MARYSVILLE ARCHITECTURAL REVIEW BOARD

SUBJECT: Consideration of a Minor Use Permit and Design Review Application for a new Single-Family Home on a vacant lot in an M-1 Light Industrial Zoning District at 1322 High Street. APN **Planning Department File No. MUP24-02/DR 24-15**

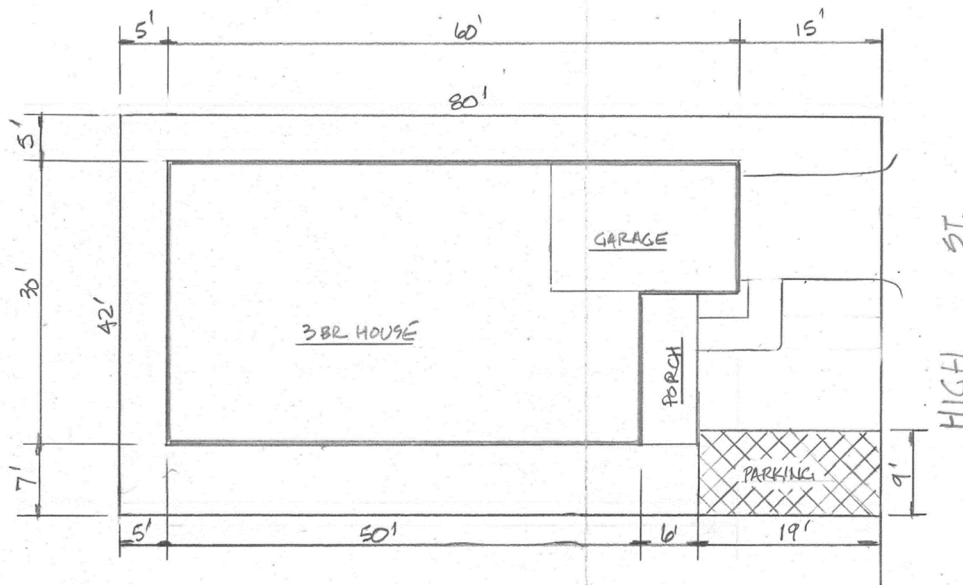
Staff would suggest the front door be painted the same blue as the gable end, and that the window trim be an "off white" like that shown on the image above. Staff would also suggest windows be provided in the garage door panel to visually improve the front elevation. Also, if "Z" seams are between the T1-11 panels, they be concealed with the same 1" x 6" trim around the windows.

10. It is recommended that the front door be painted Van Deusen Blue HC-156 the same blue as the gable end of the front elevation.
11. Window trim shall be a minimum of 1" by 6" and shall be an "off white."

12. It is recommended that windows be provided in the garage door panel to visually improve the front elevation.
13. If "Z" seams are between the T1-11 panels, they must be concealed with the same 1" x 6" trim around the windows. The concealing trim may be painted the base color of the building at the discretion of the applicant.
